**Skilled Nursing Care / Mental Health Unit /
HIV – AIDS Unit and Renovation of Related
Support Facilities for
ELAYN HUNT CORRECTIONAL CENTER
LA State Project No. 08-413-97B-1, Part 7**

Addendum No. Three

ADDENDUM INFORMATION CIVIL
ELAYN HUNT SKILLED NURSING FACILITY
State Project No. 08-413-97B-1, Part 7
F&T Job No. 84637

2 ENLARGED PLAN - HRDC BUILDING
 0 2'-0" 4'-0" 8'-0"
 SCALE: 1/4" = 1'-0"

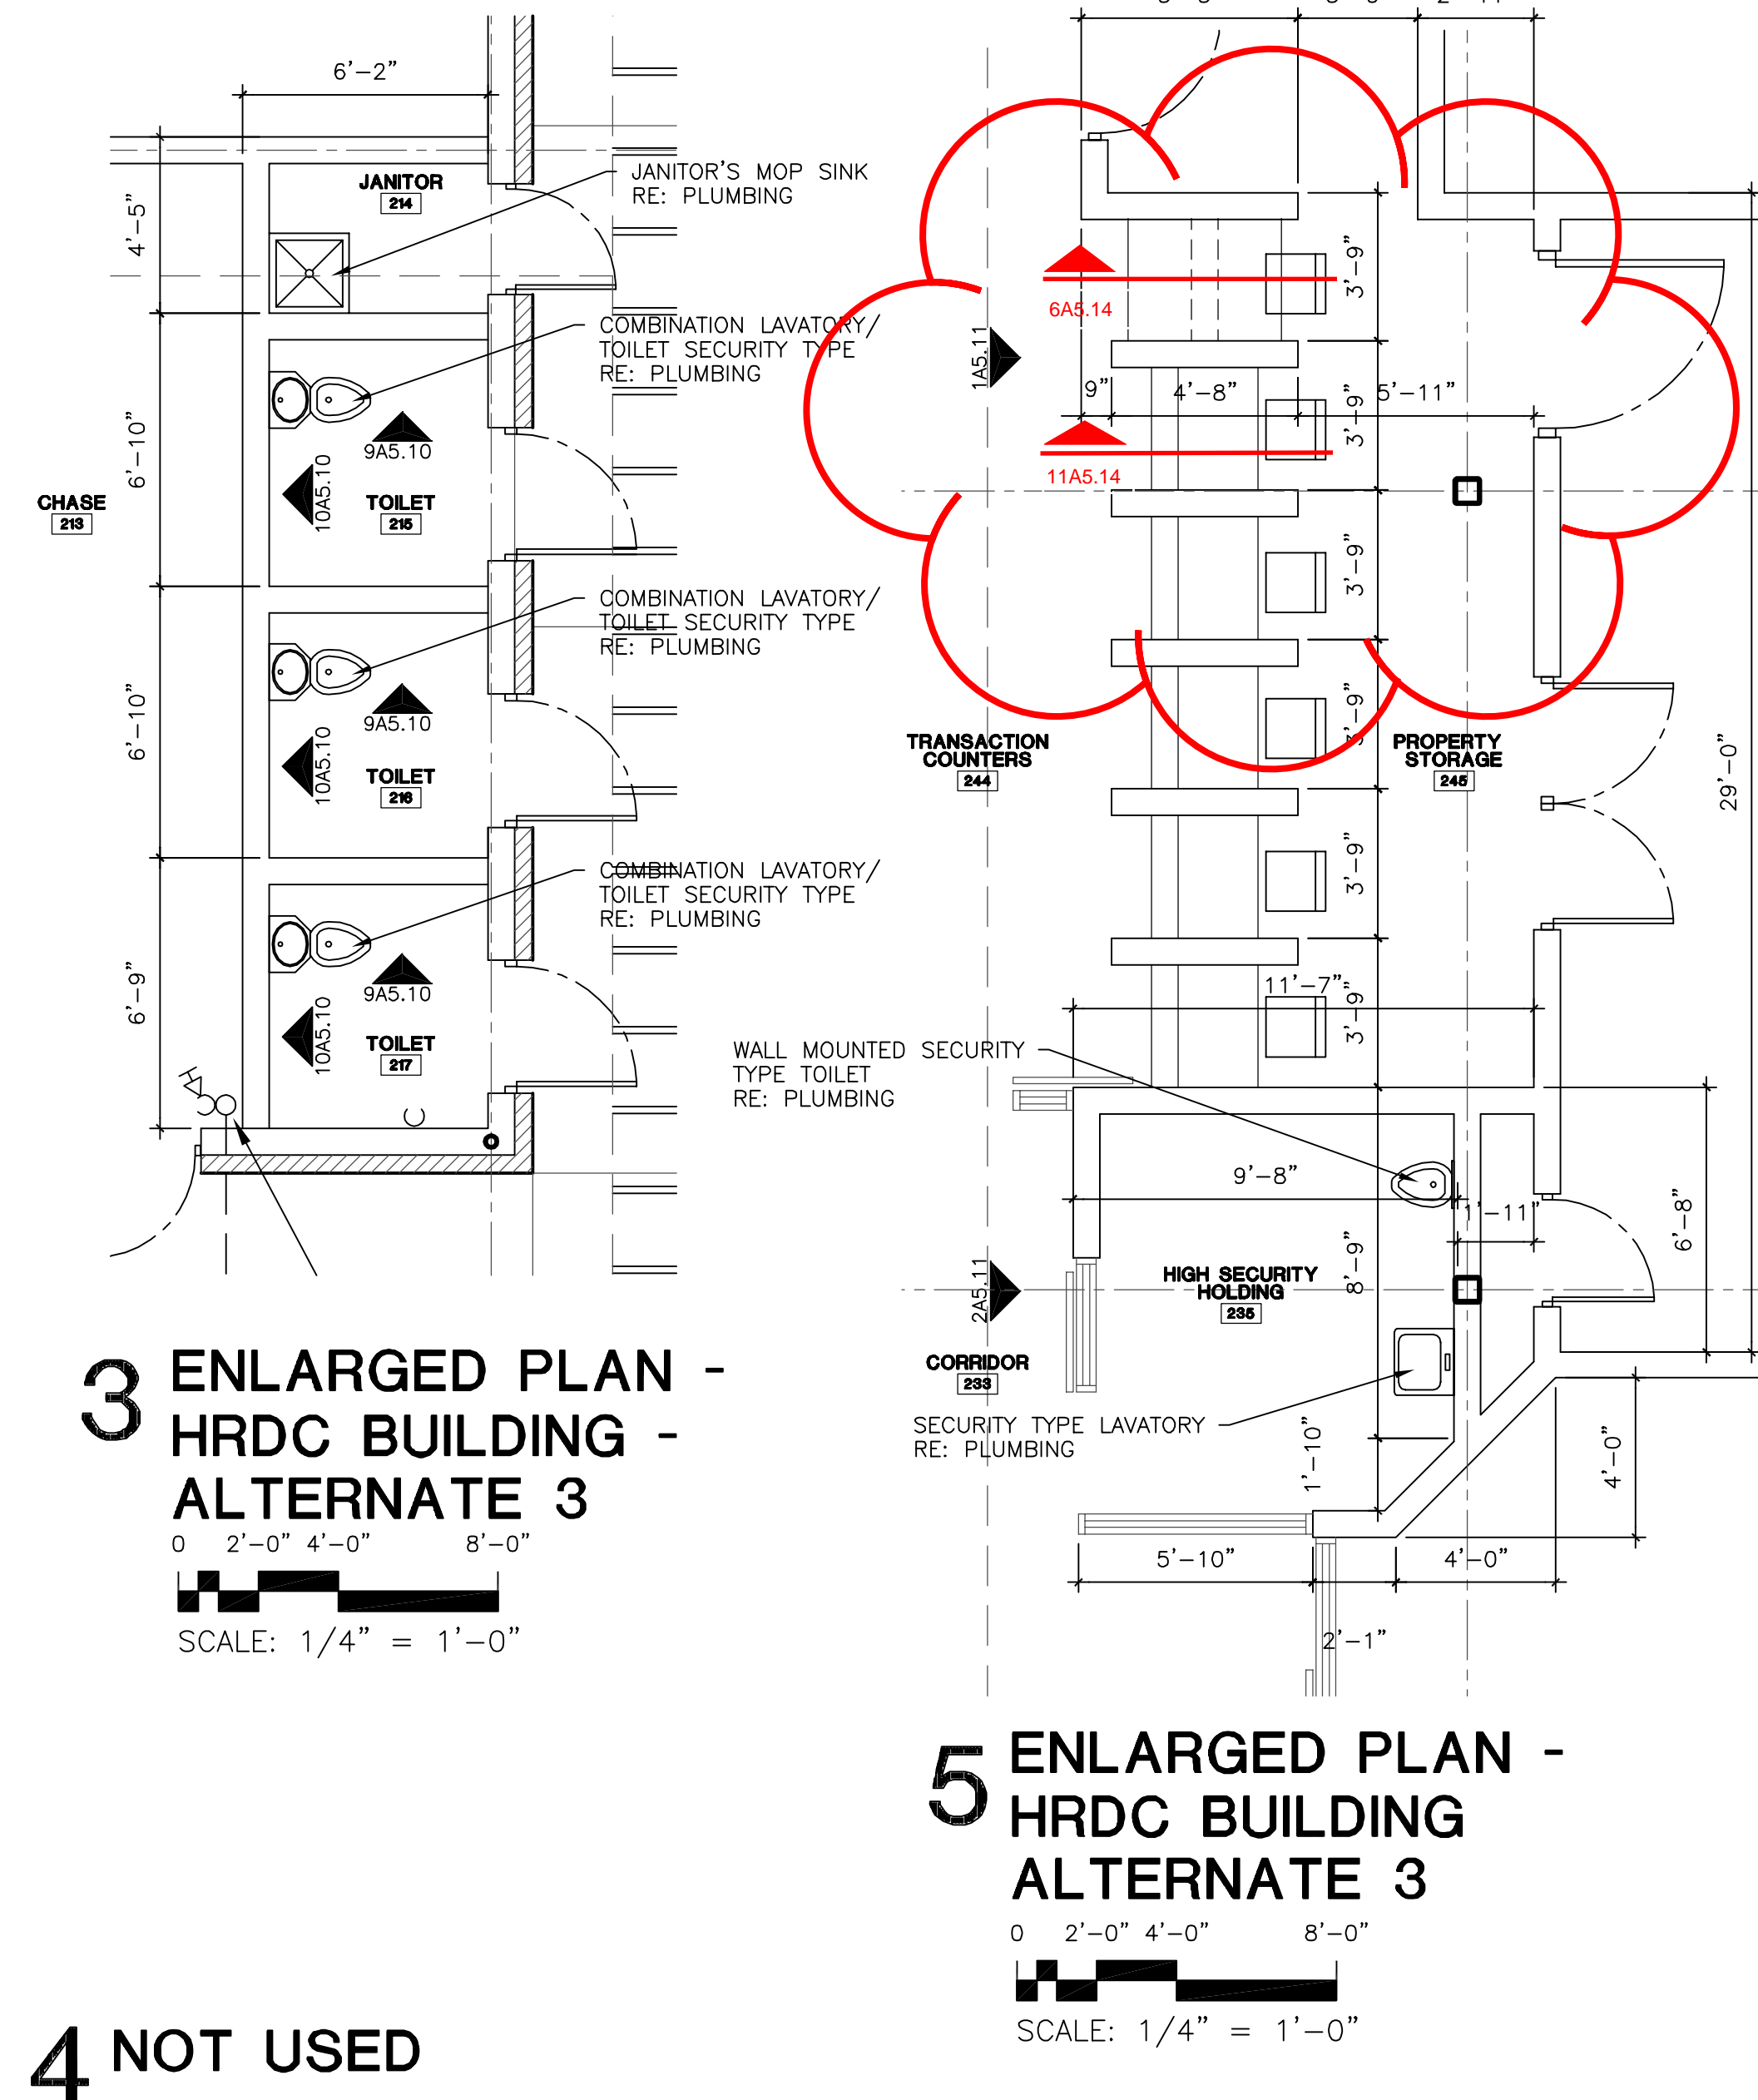
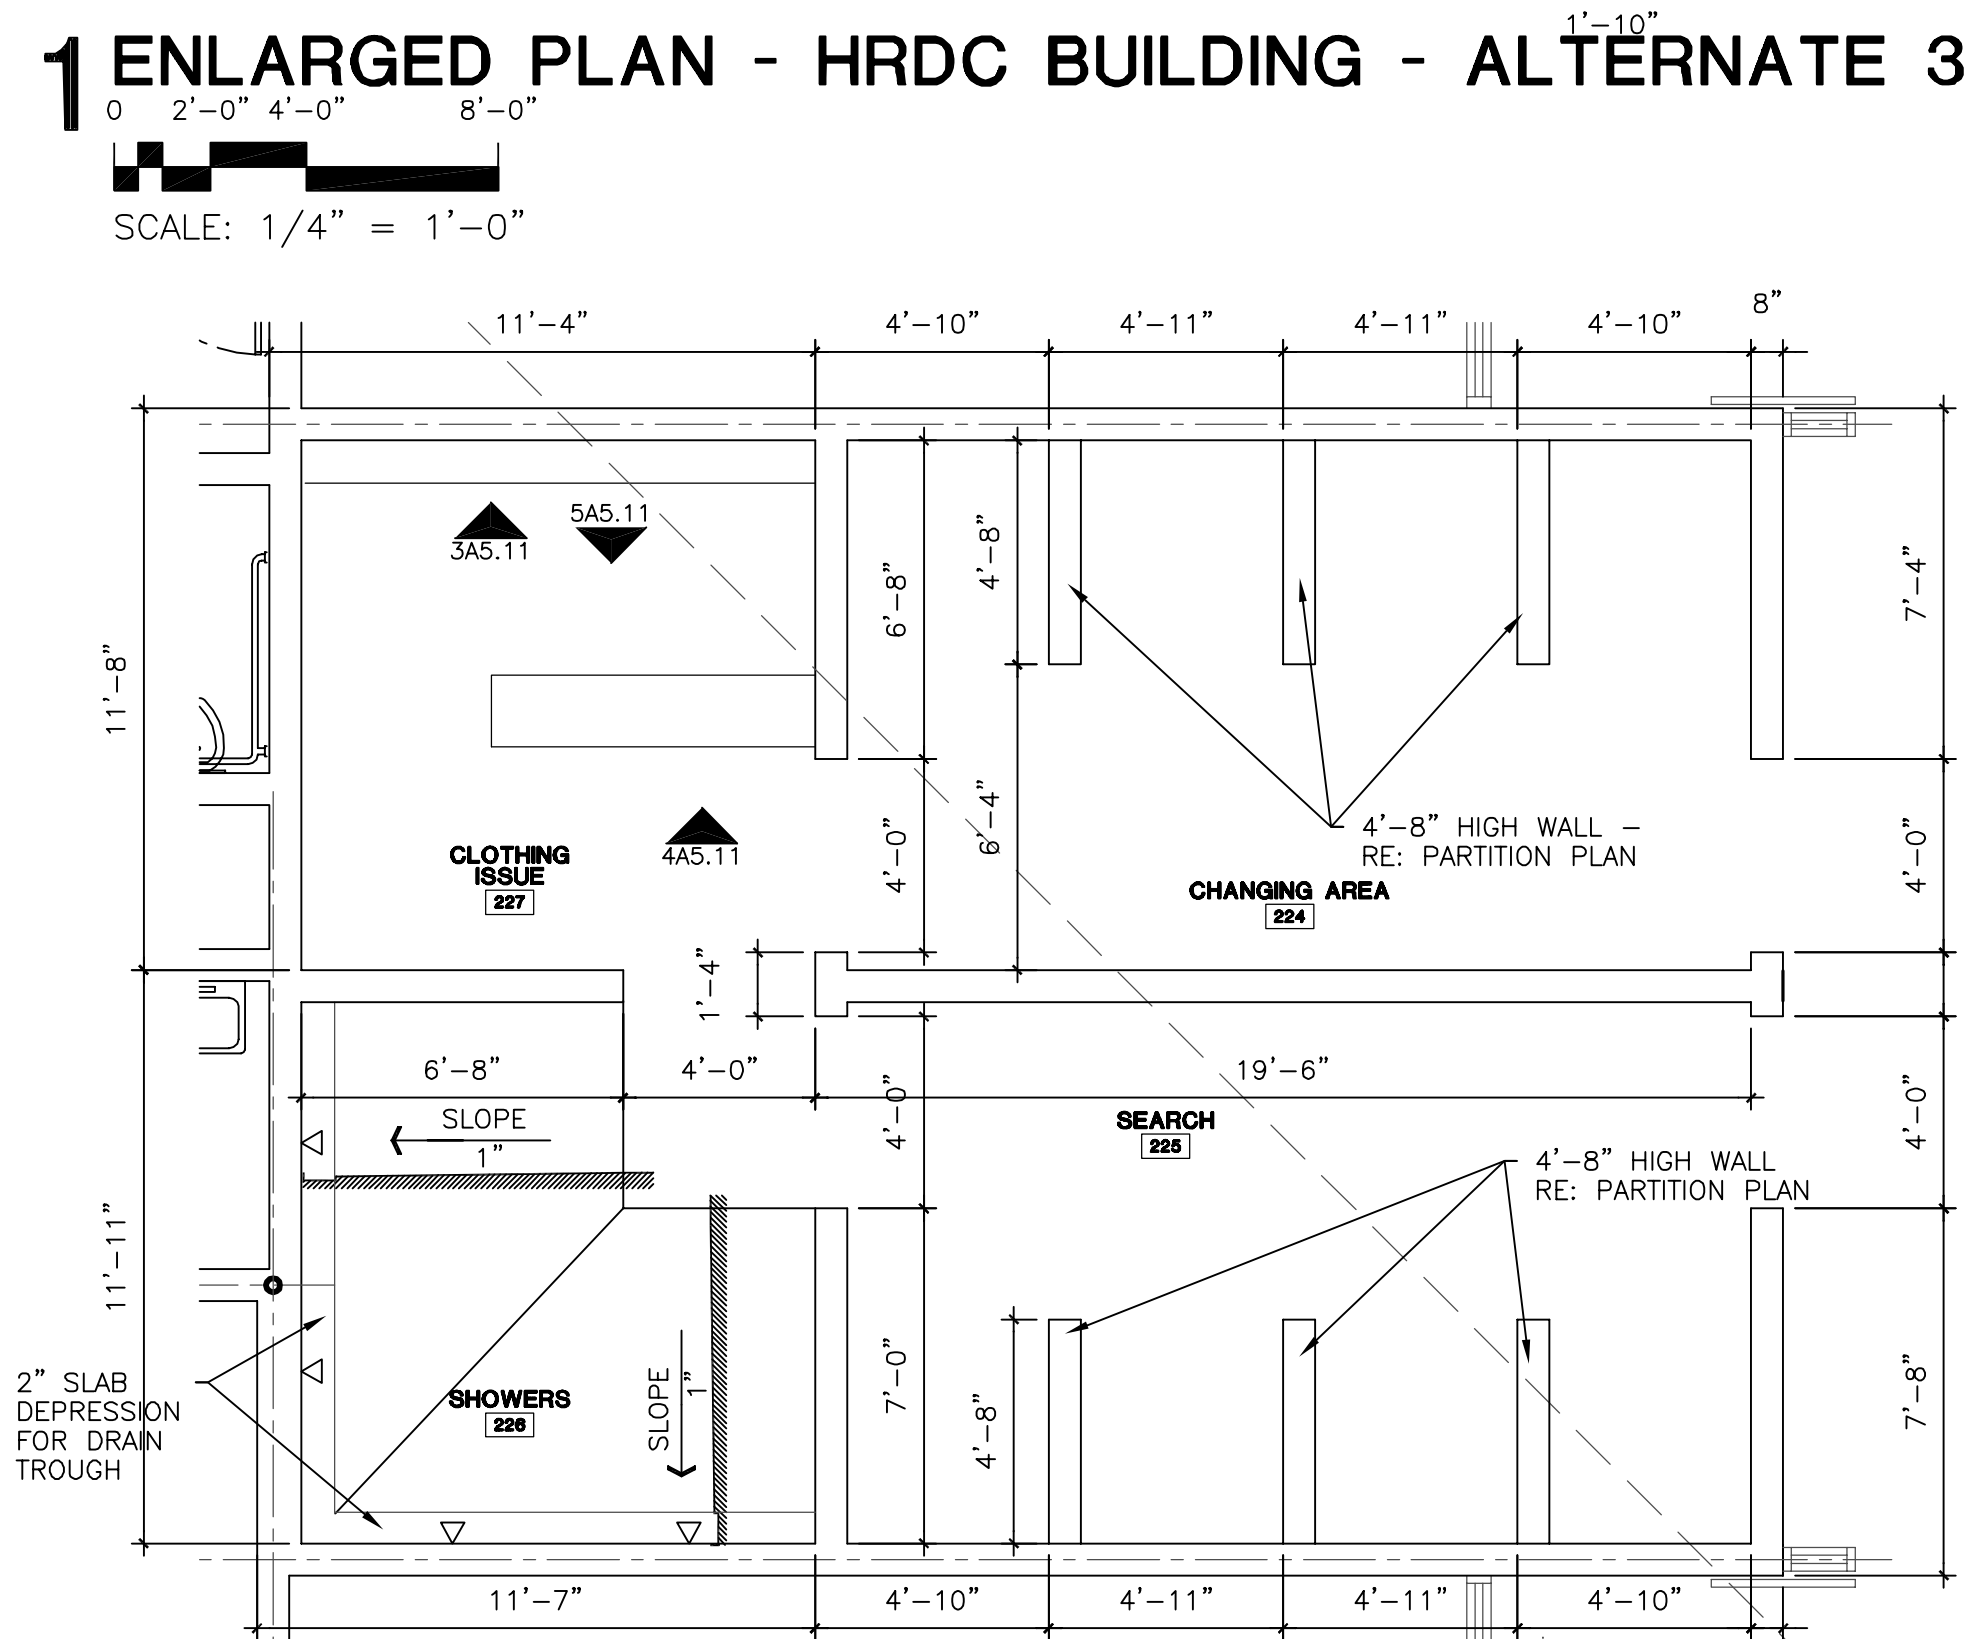
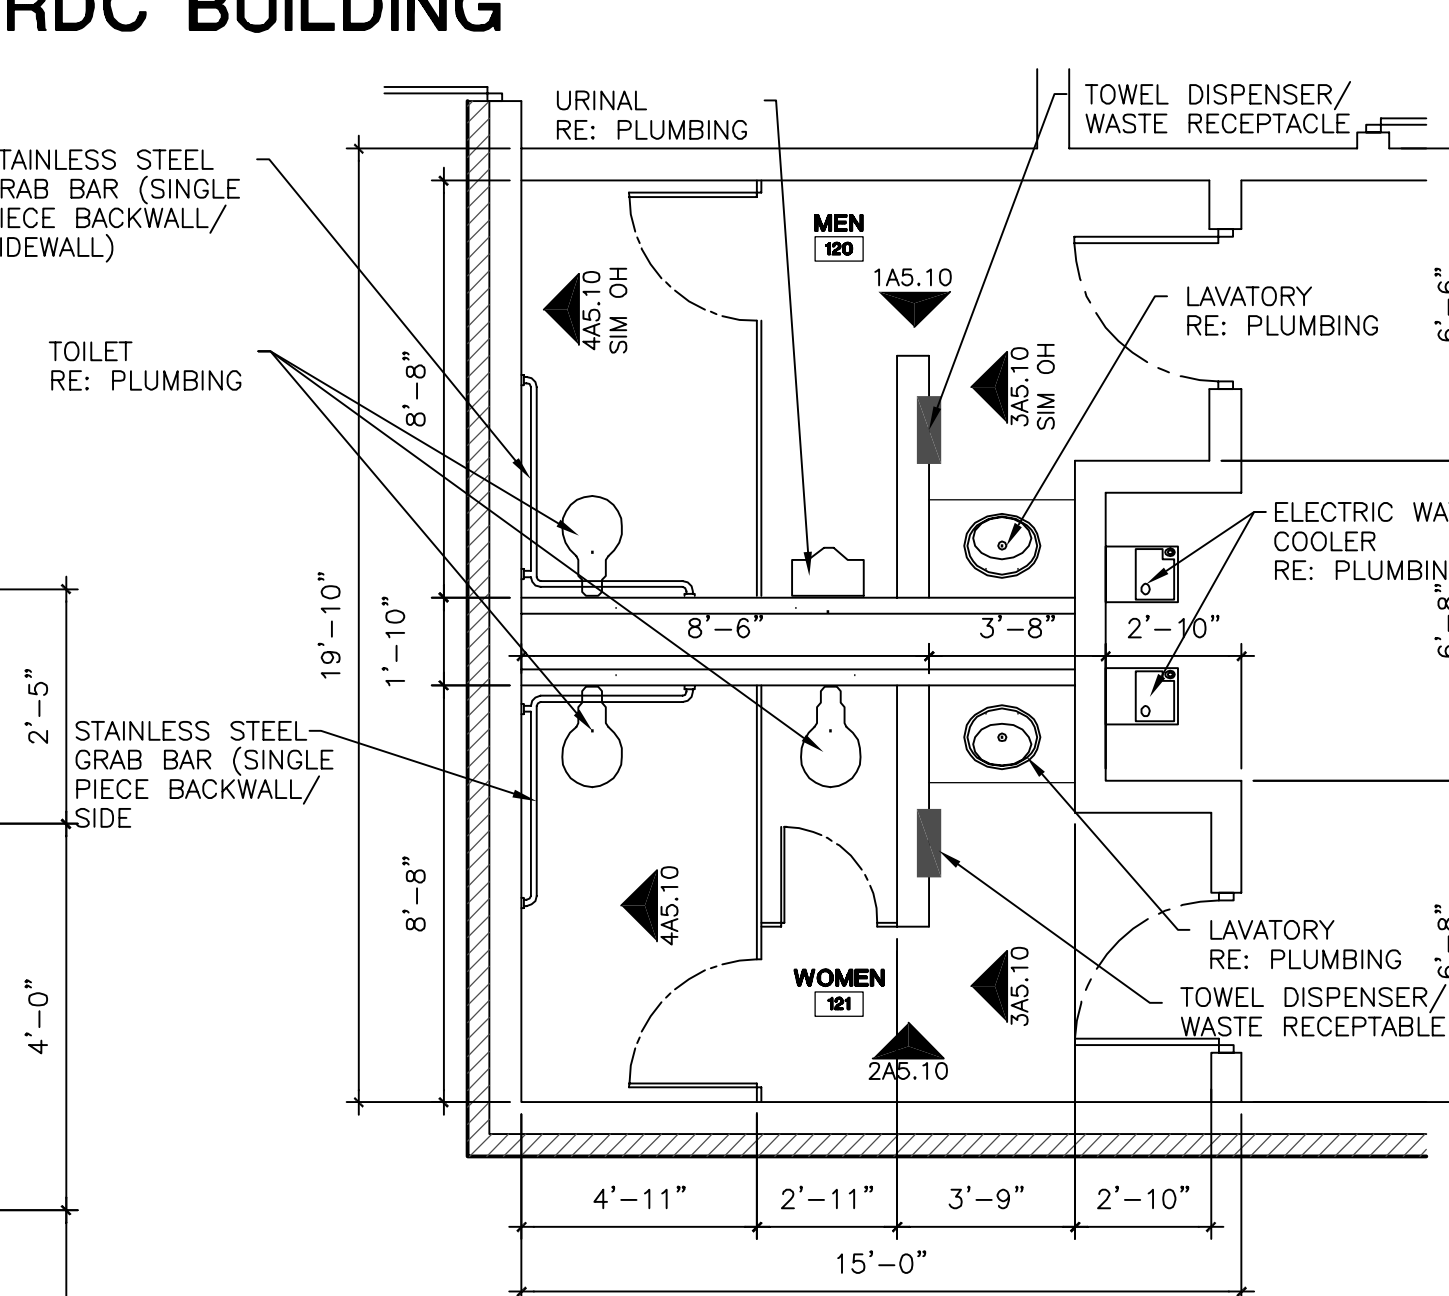
- 9) Please see attached revised A2.14 for clarification of transaction counters.

- 10) The wall height for the 4'-8" walls separating the transaction counters shall be to the underside of the metal deck.
- 11) Specification Section 07620 calls for pre-painted aluminum. This should be revised to state pre-painted steel.
